**Subject:** **AMENDMENT NO. 4 TO THE INVITATION FOR BID NO. IFB-CO-13733-BRASS-BGR**  
**PURCHASER ANSWERS TO CLARIFICATION REQUESTS**

**'Provide Broadcast, Maritime Rear Link And Ship-Shore Baseline Implementation South in Bulgaria (BRASS-BGR)'**

5. The purpose of this Amendment No. 4 to the IFB is to publish the answers to the Clarification Requests received from Prospective Bidders (Attachment (B), CRs T183-T226), and to amend the subject IFB accordingly.

**Figure 5:** BRASS BGR Overview and System Architecture

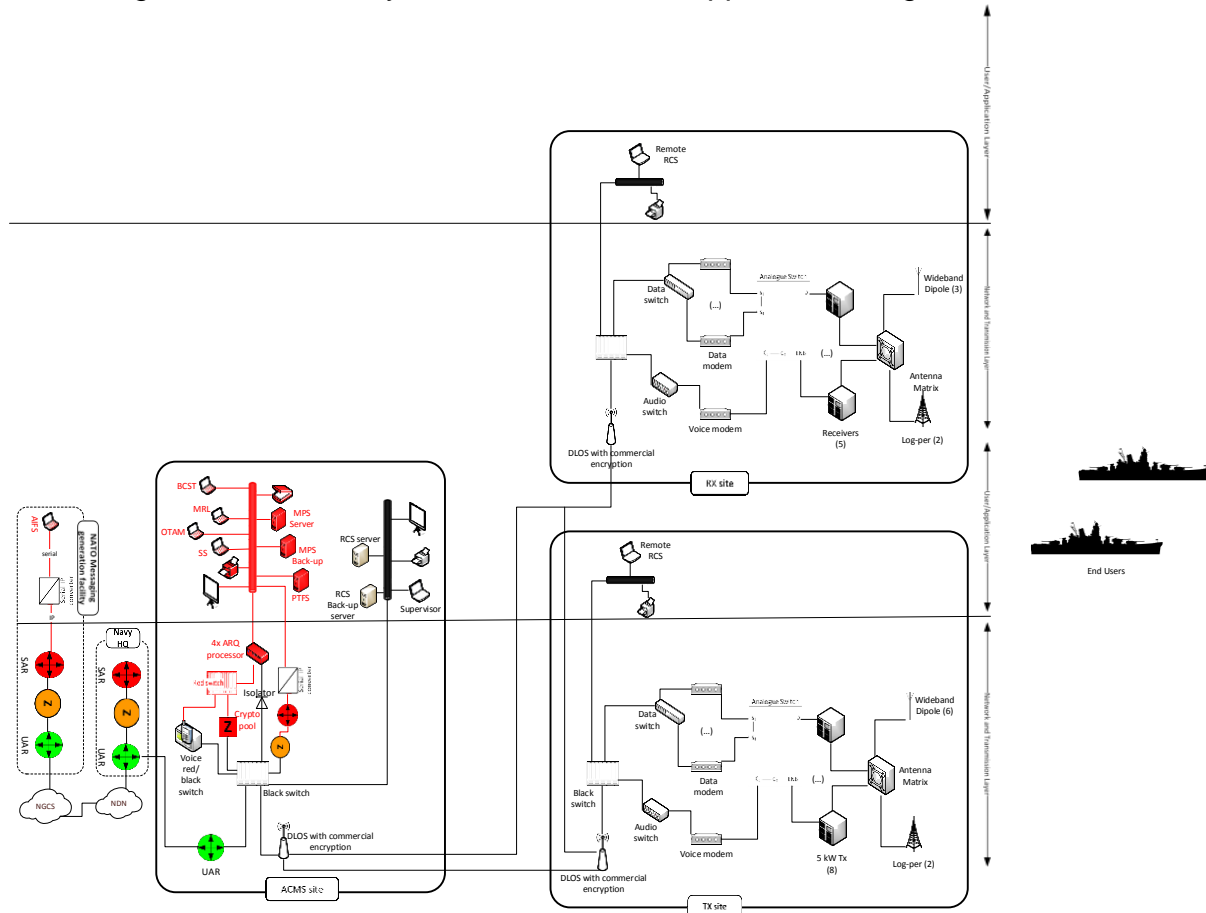
<b>T.213</b>	SOW ANNEX-A 6.12.1.a,b,c, Figure 5 in para. 6.1	As specified in 6.12.1 bullet a the total number of receivers is five (5), while as specified in 6.12.1 bullet b and c the total number of modems are in a different number, i.e. eight (8). Besides, in figure 5 of BOOK II PART IV ANNEX-A para. 6.1 page 23 are specified eight (8) receivers. Please confirm the total number of receivers and modems requested.	For the number of modems in Rx site; please see SSS CLIN 7.1.2 and 7.1.6 as well as SOW Annex-A 6.12.1.b and c. For the number of receivers in Rx site please see SSS CLIN 7.3.1 and SOW Annex-A 6.12.1.a,  Figure 5 is a generic drawing. However, it will be modified as to show 5 receivers in Rx site to avoid confusion.	Yes, IFB AMD4

Serial NR	IFB REF	BIDDERS QUESTION	NCI AGENCY ANSWER	STATUS*
<b>T.214</b>	SOW ANNEX-A 6.12.1.f. Figure 5 in para. 6.1	Figure 5 of BOOK II PART IV ANNEX-A para. 6.1 page 23 specify one (1) Wideband dipole, while 6.12.1 bullet f. specify three (3) Wideband Horizontal Dipole Antenna. Please specify the correct number of Wideband Horizontal Dipole Antenna.	For the number of Wideband dipole antenna in Rx site; please see SSS CLIN 7.3.4 and SOW Annex-A 6.12.1.f  Figure 5 is a generic drawing. However, it will be modified as to show 3 Wideband Dipole Antennas in Rx site to avoid confusion.	Yes, IFB AMD4
<b>T.215</b>	SOW ANNEX-A 6.11.1. d. 6.12.1.b.	What do you mean for "1 time" in the statement: "six (6) modems STANAG 4285/STANAG 4197 compliant; 1 time (1-BCST, 4-S-S, 1-MRL);"	It is related to one of the Operational Requirements. However, the term "1 time" will be deleted from the paragraphs 6.11.1.d and 6.12.1.b to avoid confusion.	Yes IFB AMD4

Figure 7: Equipment cooling example.

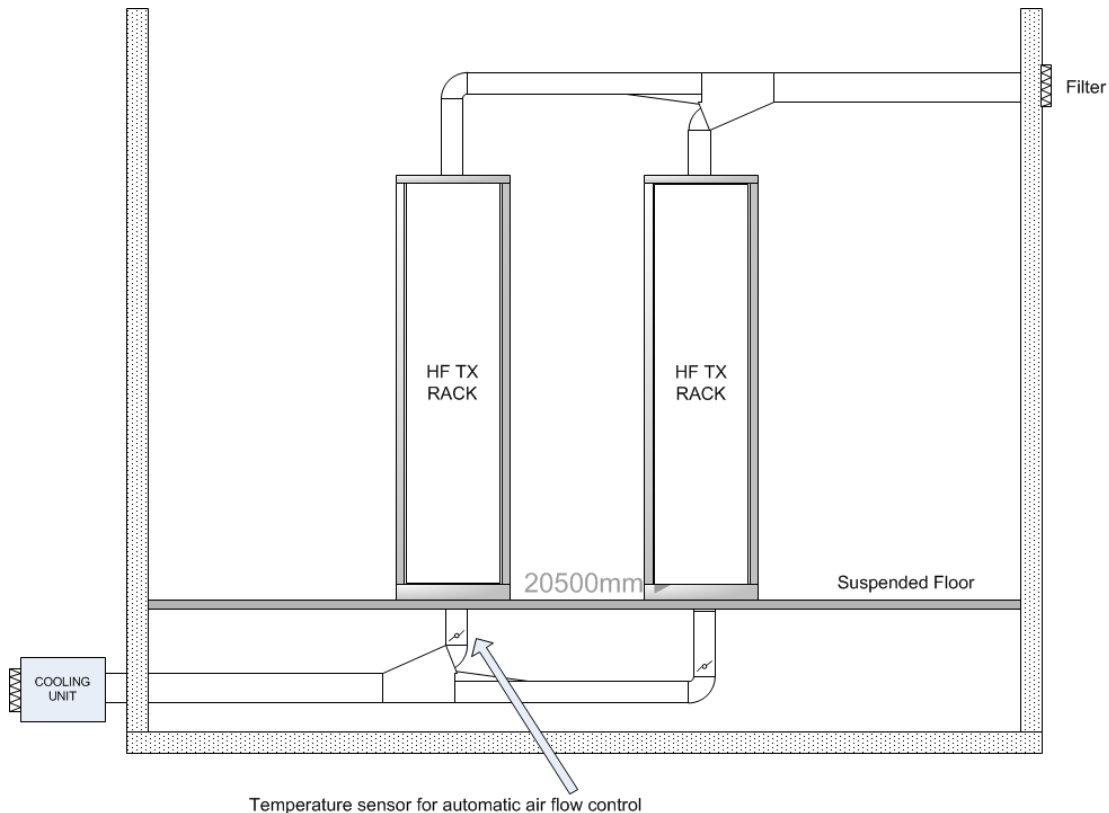
Serial NR	IFB REF	BIDDERS QUESTION	NCI AGENCY ANSWER	STATUS*
T.89	BOOK II PART IV ANNEX-A PAGE 56 Paragraph 6.11.8 a.i	<p>The paragraph 6.11.8 a.i says that “Cooling System for HF transmitters shall have Close circuit operations.” Most of the transmitter vendors advice that hot air shall be exhausted to outside of the building.</p> <p><b>Q:</b> Does the defined requirement mean that exhausting hot air will be connected to the intake air part of cooling unit via air ducts?</p>	<p>The exhausting hot air will not go outside but will be used by the A/C cooling unit.</p>	No

Serial NR	IFB REF	BIDDERS QUESTION	NCI AGENCY ANSWER	STATUS*
T.90	BOOK II PART IV ANNEX-A PAGE 56 Paragraph 6.11.8 b & 6.11.7.d	<p>The paragraph 6.11.8 b writes that - “ii. The cooling system shall be of heat-pump type, air/air reversible, with split unit installed on the walls.”, - “viii. The air flow shall be in ducts.” and “Figure 7: Equipment cooling example”,</p> <p>“The paragraph 6.11.7.d writes that - xxiii. Cooling: forced air”</p> <p>We understand that the cooling system will be consisted of two different sub cooling system one of which is split type cooling system, the other is forced air cooling system.</p> <p><b>Q.1:</b> Please clarify quantity of the required cooling system? <b>Q.2:</b> Please clarify providing responsibility of the above-mentioned cooling system?</p>	<p>1) There is no cooling system at the moment for the national equipment.</p> <p>According to the Initial design - one heat-pump type system, but it is up to Host Nation’s Designer to choose at a later stage.</p> <p>Please also see Appendix-2 to SOW Annex-C (draft SPDP prepared by NCI)-</p> <p>2) providing cooling system in transmitter room is the Host Nation’s responsibility</p>	No
